State Significant Development Application Response to Submissions

SSD-122745741 Shop-top Housing Development
120-122 Smith Street, Wollongong

Prepared for The Smith St Development Partnership

Figure 2 Originally proposed (left) versus revised (right) vehicular access arrangements
Source: Cox Architecture

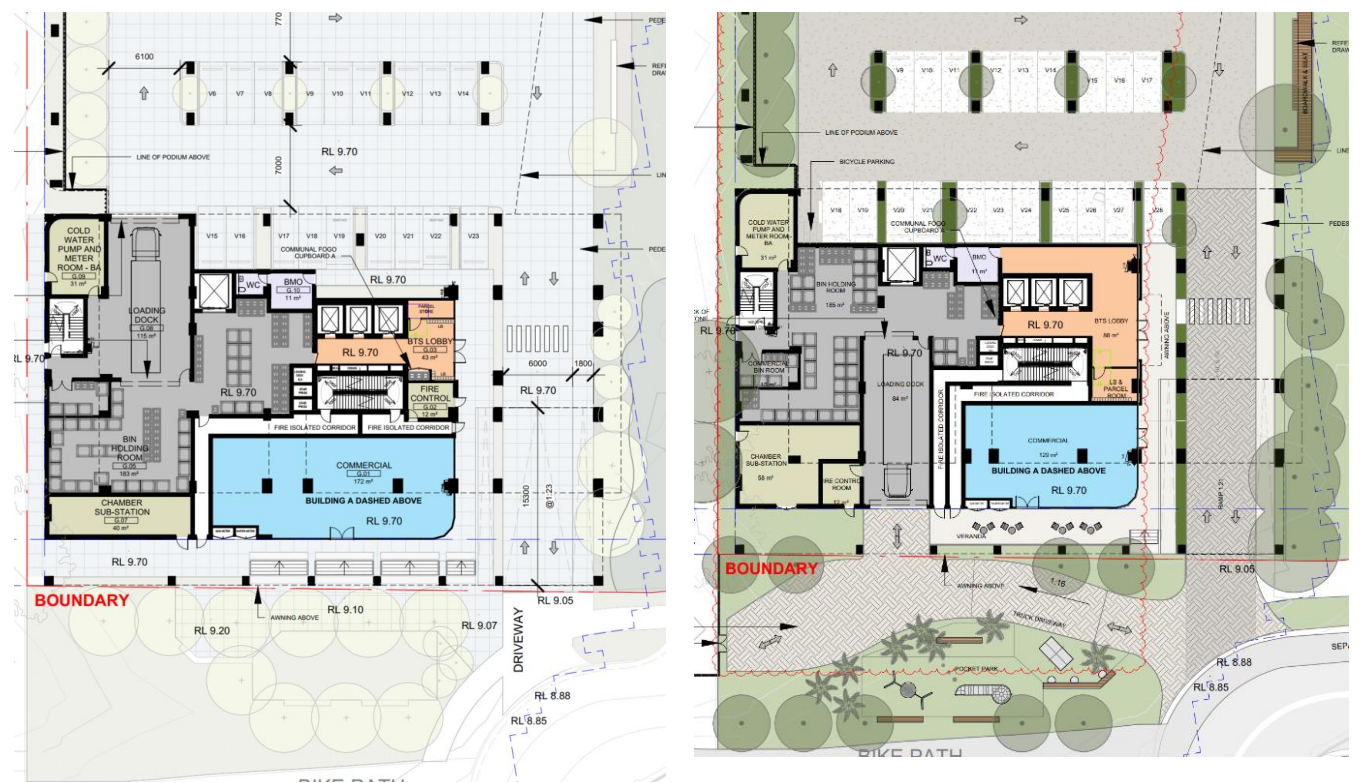
This change has been made in response to Item 4 of the Department’s Letter, being:

- 4) Waste management
Provide waste management facilities in accordance with Council’s requirements. This may require a redesign of the ground floor layout to ensure that the loading dock area is separate to all other residential, commercial and visitor parking and circulation areas.

Amendments have been made to the vehicular accessway include the separation of the private vehicle and truck entryways within the development. As shown in **Figure 2**, while the two accessways still share a crossover on Smith Street, they now divert from one another prior to entry into the site, with the new truck entryway on the southern façade and the private vehicle entrance remaining below the porte cochère.

This change has resulted in the refinement of the pocket park, waste storage and collection area, and commercial tenancy to suit the new access arrangements. Specifically, the footprint of the indicative pocket park and commercial tenancy are reduced in size to accommodate the separate loading dock, and waste storage areas have also been adjusted accordingly.

Figure 3 Originally proposed (left) versus revised (right) ground plane activation
Source: Cox Architecture

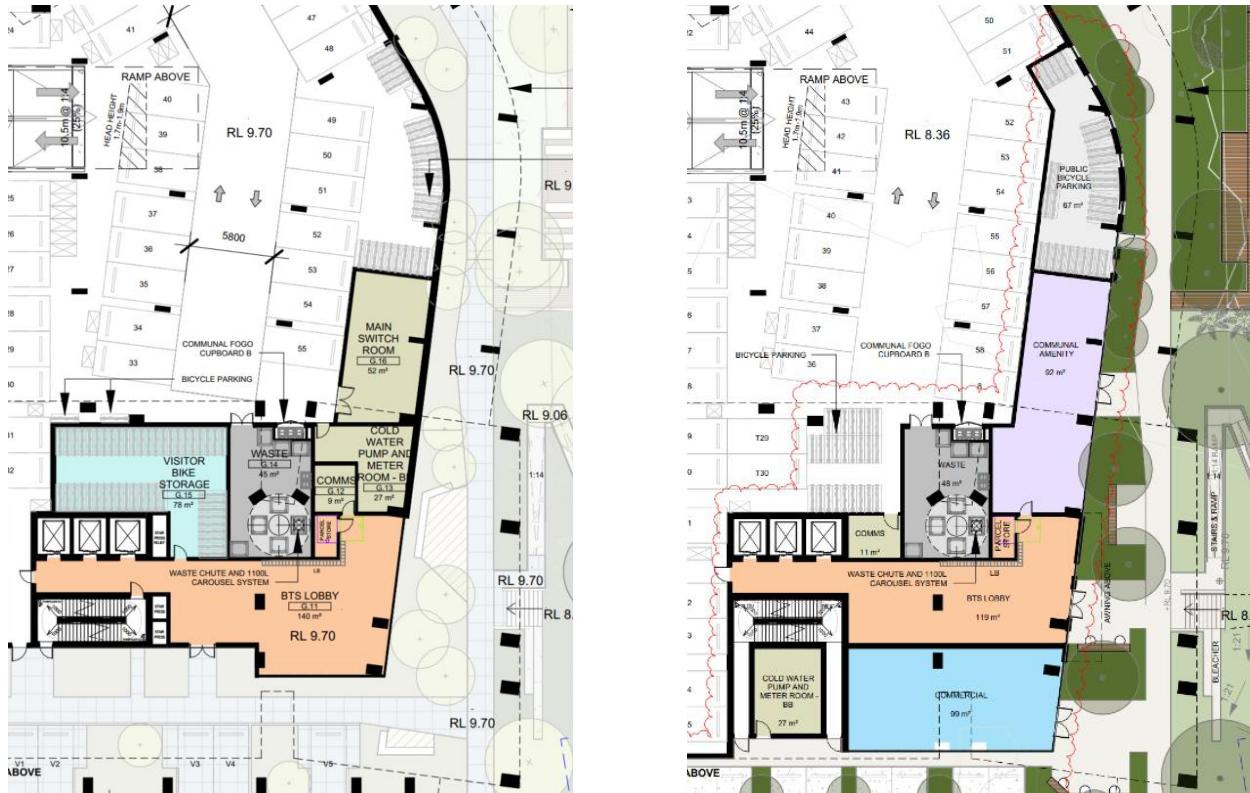
In their correspondence, the Department raised concern with the length of the wall on the eastern façade between the Building B and Building C lobbies and potential Crime Prevention through Environmental Design (CPTED) concerns. Further, they raised that pedestrian wayfinding can be more clearly outlined in documentation and incorporated into early design consideration.

Council similarly raised concerns regarding the activation and surveillance of the central pedestrian path through the site. Council recommended that active or communal uses should be incorporated to better serve residents and activate the central landscaped space, and that consideration should be given to the quality and presentation of the car park screening adjoining the walkway, with the screening expected to make a positive contribution to the aesthetic quality of the development.

As shown in **Figure 3**, a further change has been made to the ground floor to integrate further activation into the through-site link on the site’s eastern façade. The changes specifically include the introduction of an additional commercial tenancy and a communal amenity space which are accessible from the through-site link. These spaces are located either side of the Building B lobby and result in improving activation.

As detailed in **Section 3.2.1** and shown in **Figure 2** and **3**, the ground floor arrangement has been refined to respond directly to the concerns raised regarding inactivity and wayfinding. The revised design introduces an additional commercial tenancy and a communal amenity space, both of which are directly accessible from the through-site link. These uses are positioned on either side of the Building B lobby, creating additional points of activity and pedestrian engagement along this section of the site. The introduction of these spaces reduces the extent of blank and inactive wall frontage and provides greater visual connection between the internal uses of the development and the through-site link. The revised arrangement also strengthens the relationship between the central landscaped space, pedestrian movement through the site and the communal and commercial uses, resulting in a more active and legible ground floor interface.

Figure 5 Originally proposed (left) versus revised (right) Building C Level 10

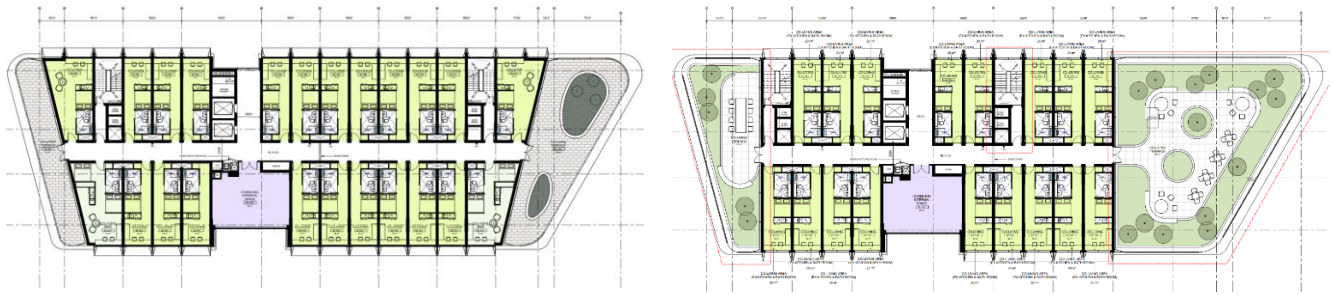
The Department has queried the increased extent of the upper levels of Building C since SDRP #2, and the potential impact this may have on views to Mount Kembla. The Department has requested a comparison between the SDRP #2 and SSDA schemes. It was also recommended that the setbacks to the upper levels of Building C be increased to minimise the perceived bulk and scale of the development and reduce view loss, generally aligning with the setbacks previously considered by SDRP #2.

Several changes to the proposed co-living building (Building C) have been made. Most notably and as shown in **Figure 5**, an increased setback to level 10 in Building C is proposed, increasing the outdoor communal open spaces on both the eastern (setback a further ~12.5m) and western (setback a further ~6m) side of the level.

This has resulted in a reconfiguration of co-living rooms, including the reduction of 15 rooms and a minor fire stair amendment. The additional setback has resulted in an additional 227m² of open space provided for Building C.

Despite this, as increased setback to the upper level of Building C has been made to align more closely to the SDRP #2 scheme. This allows for a greater view to the escarpment to be gained as opposed to what was originally submitted (comparison shown at **Figure 7**). Importantly, the original VIA concluded that the visual impact of the proposed development was consistent with the strategic growth of the city centre, representative of tall buildings within the context of urban renewal in Wollongong. The additional setback proposed in the revised design has only further improved the view to the escarpment, minimising the original visual impact in consideration of public views and views gained from surrounding properties as raised by the community.
